**CITY AND BOROUGH OF WRANGELL, ALASKA**  
**INVITATION TO BID**  
**CITY DOCK SUMMER FLOAT PROCUREMENT**  
**ADDENDUM TO THE PROJECT DOCUMENTS**

<b>Addendum No:</b>	<b>1</b>	<b>Previous Bid Submittal Date:</b> January 21, 2020 at 2:00pm ADT
<b>Addendum Date:</b>	<b>Tuesday, January 21, 2020</b>	
Pages This Addendum:	TWO (2)	<b>New Bid Submittal Date:</b> January 24, 2020 at 2:00pm ADT
Previous Addenda:	None

**Item 3. PAGE 5, FIRST DRAWING**

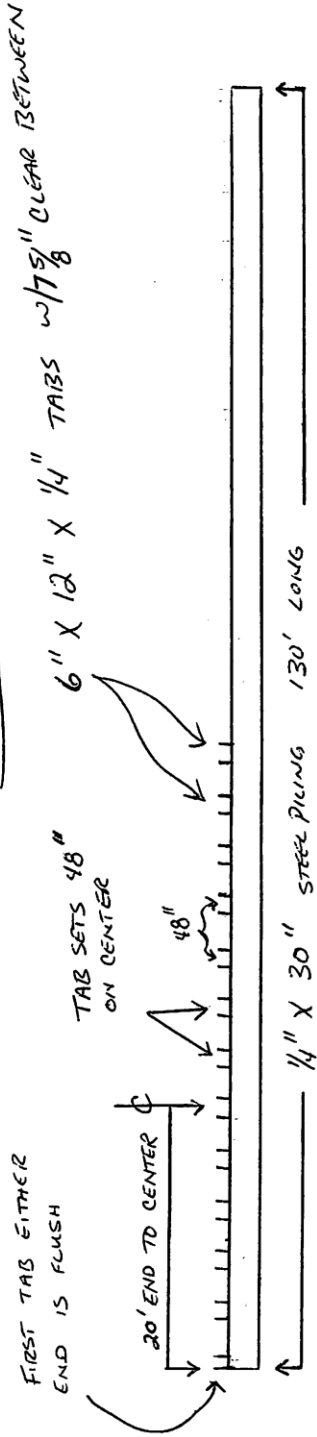
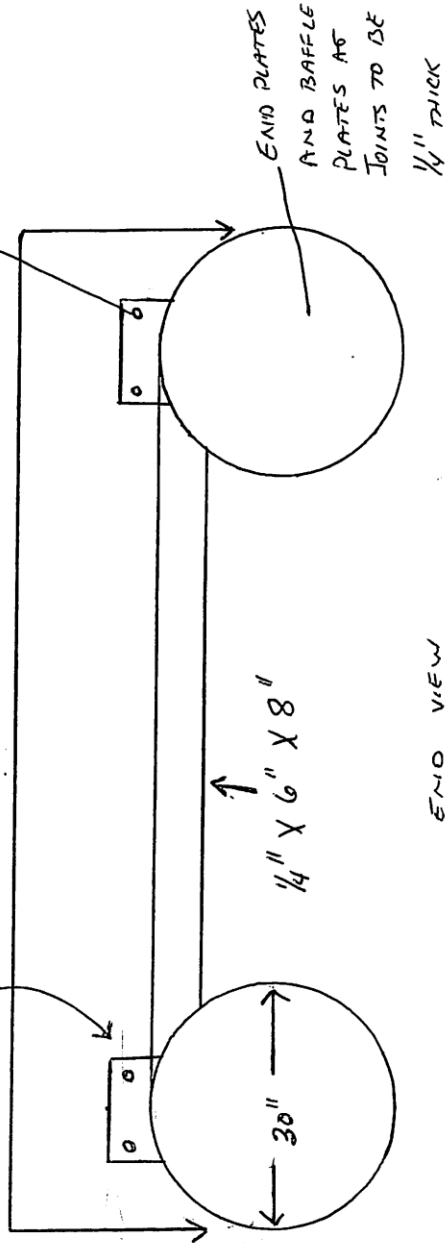
Page 5, the first drawing is replaced with the attached drawing.

BOAT HOLES MUST BE FINISHED DRILLING BE 1/2" GALVANIZING AFTER

TABS 1" X 12" 1/4" X 6"
